RE: Sunfish Lake – Planning Update for August City Council Meeting

PLANNING REPORT - Major Site and Building Plan Review & CUP

RE: Sunfish Lake – 8 Roanoke Road – Site and Building Plan Review & CUP

PLANNING REPORT – Site and Building Plan Review & CUP Addendum

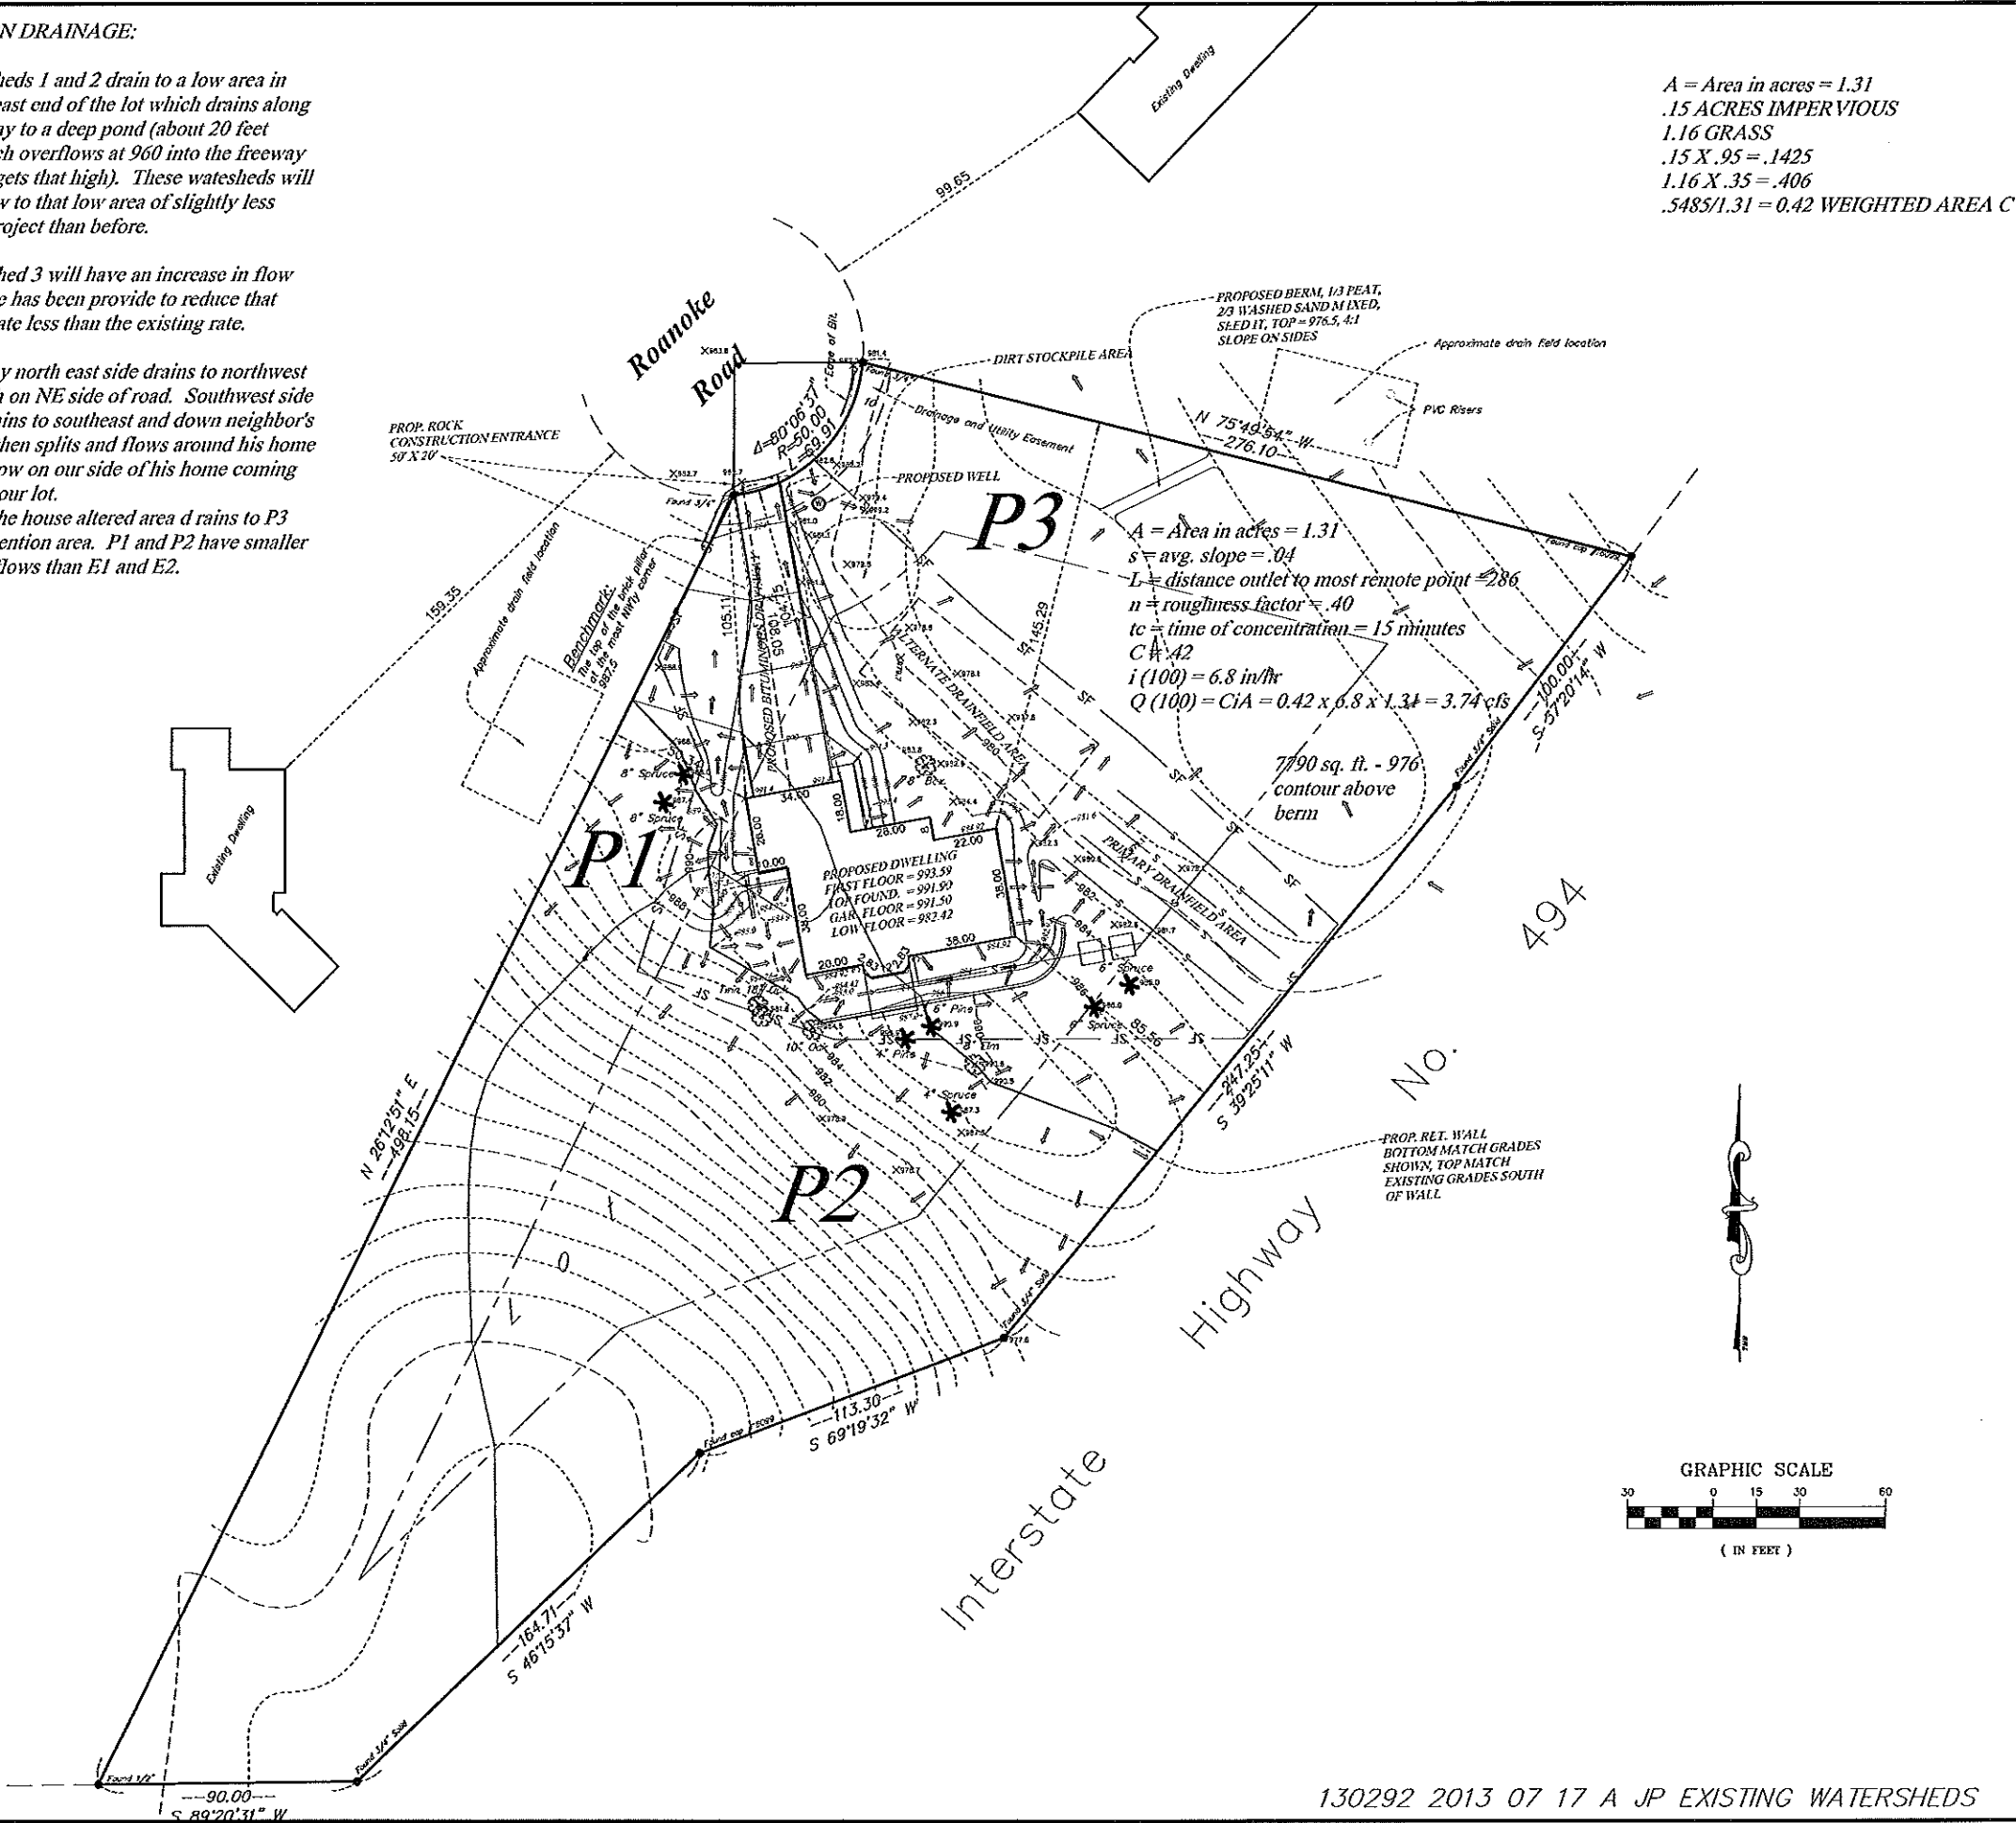
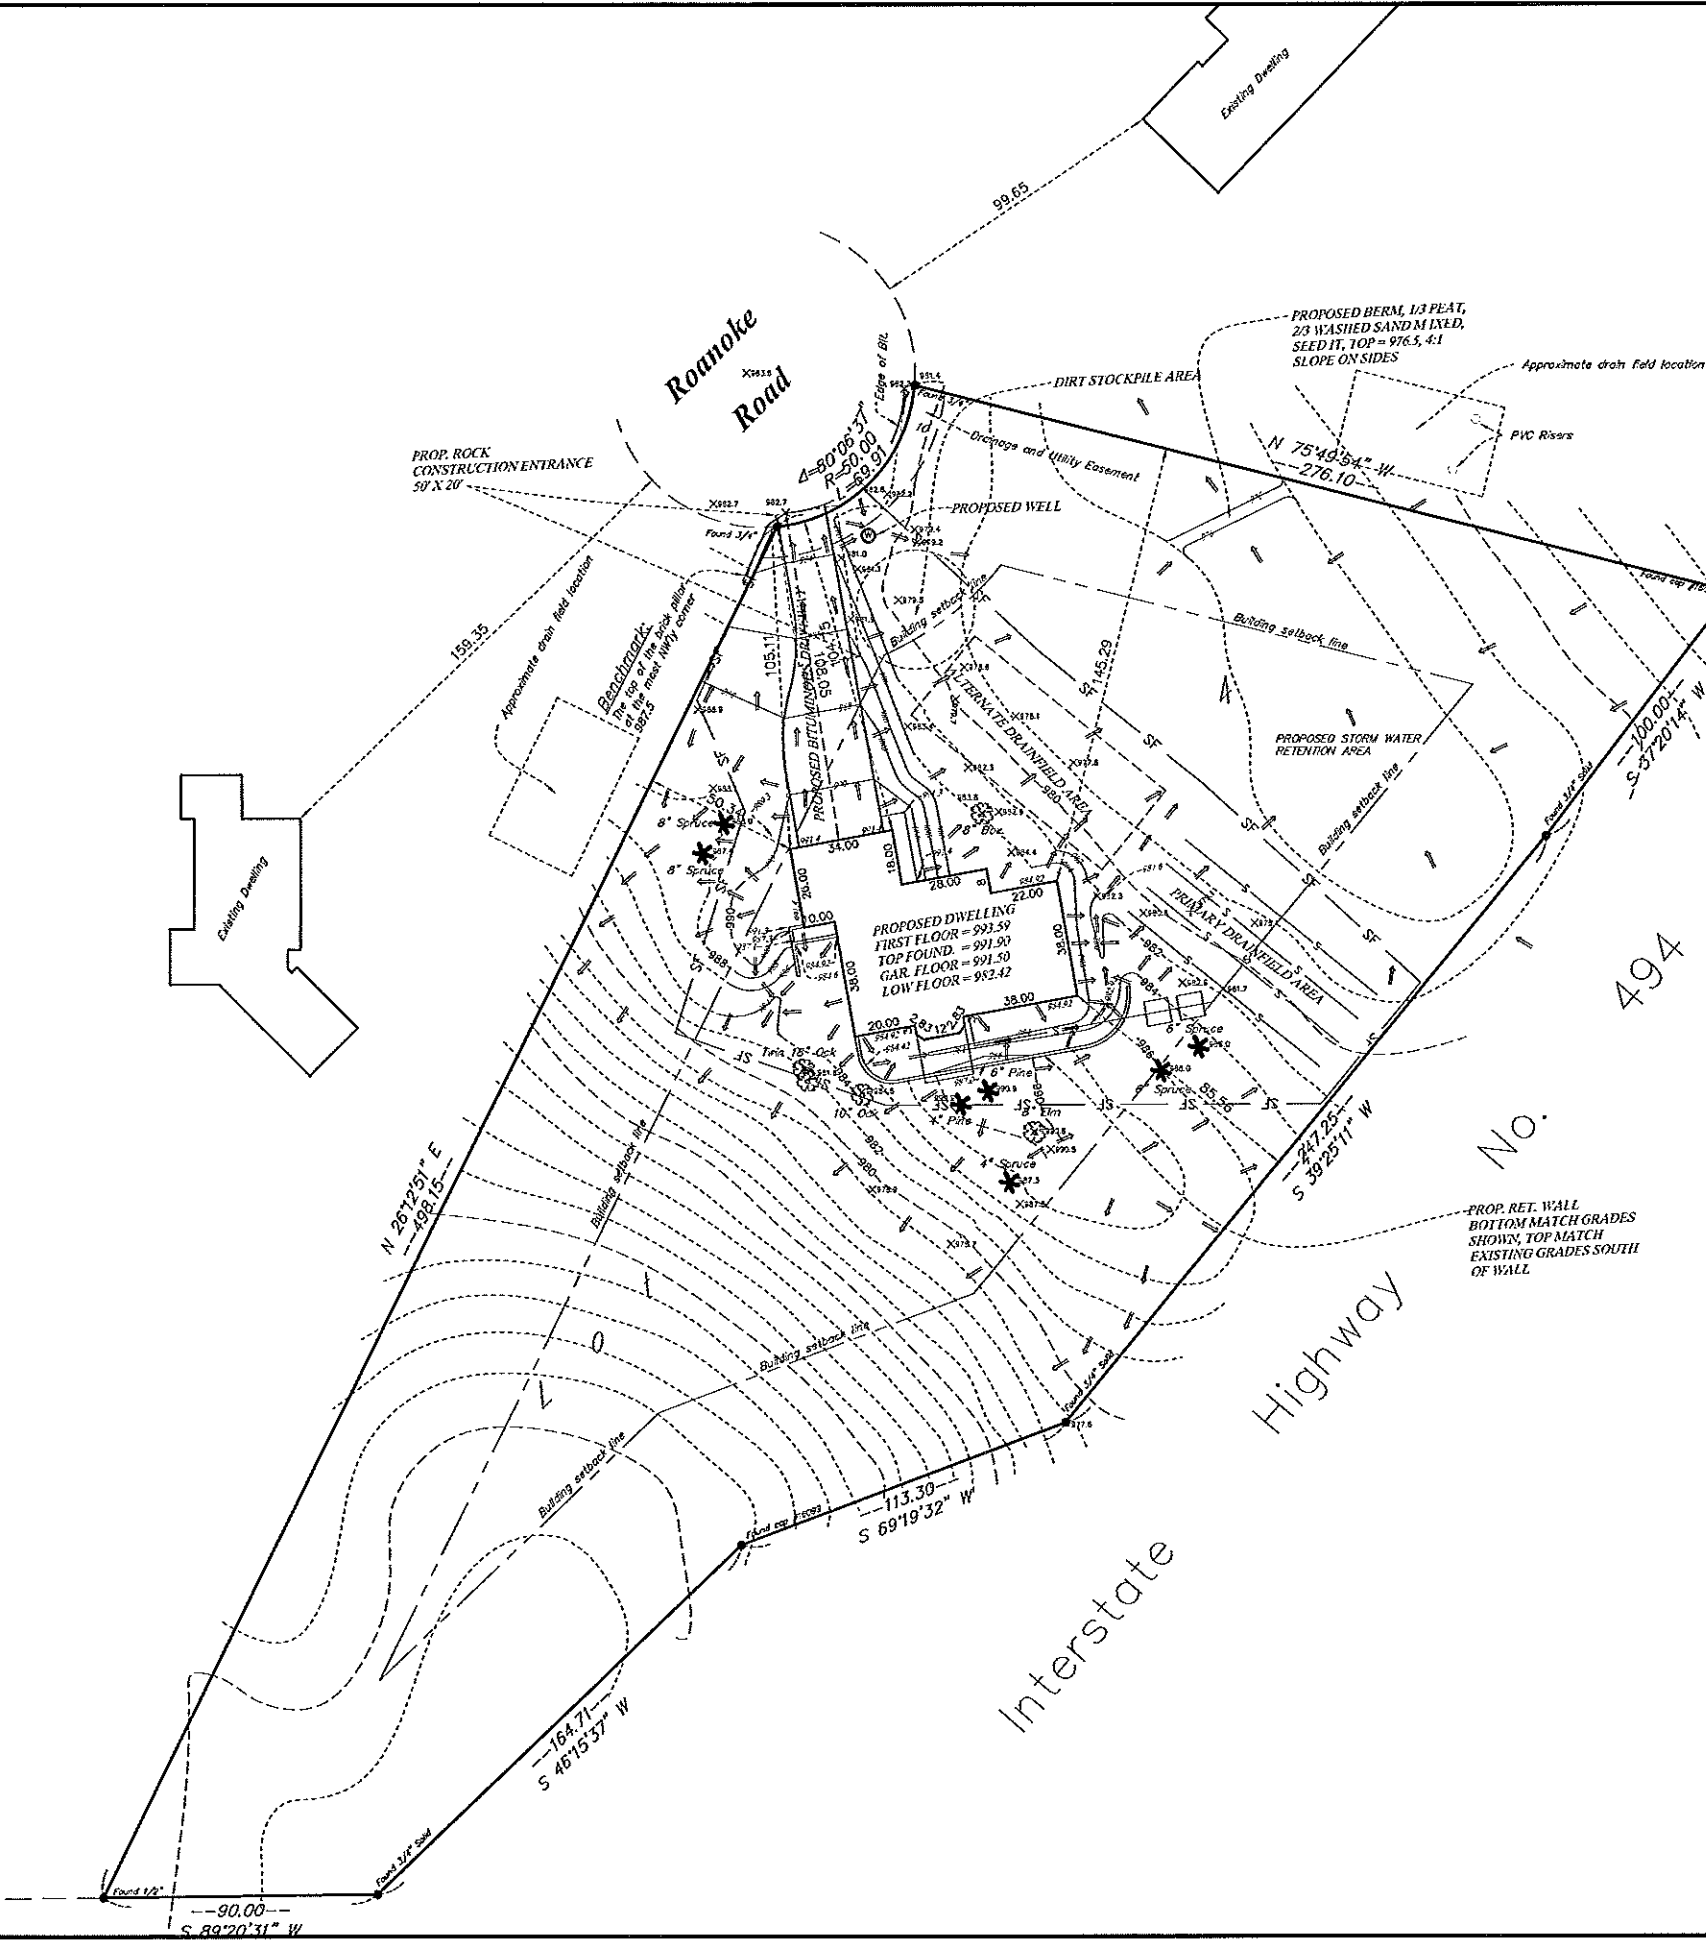
- Should label and show any trees that are to be save that may be close to construction and show tree protection fencing around these as necessary
- Provide and label areas for each of the specific drainage areas for both the existing E1-E3 drainage areas and also for the proposed P1-P3 drainage areas. Also make these lines delineating these drainage areas darker so they can be clearly seen.

- Label the total area to be disturbed. If over and acre then a NPDES Construction permit will be required per MCPA requirements
- Revise the grading plan back to the original version and I didn't think trying to get the drainage from the west side of the house around to the back to the east side would work very well or could be graded without a potential for a low spot. Also future improvements may block this and could cause ponding issues for the homeowner. He should also revise his drainage calculations accordingly.

NOTES ON DRAINAGE:

1. Watersheds 1 and 2 drain to a low area in the south east end of the lot which drains along the free way to a deep pond (about 20 feet deep) which overflows at 960 into the freeway (if it ever gets that high). These watersheds will have a flow to that low area of slightly less after the project than before.

2. Watershed 3 will have an increase in flow and storage has been provide to reduce that flow to a rate less than the existing rate.
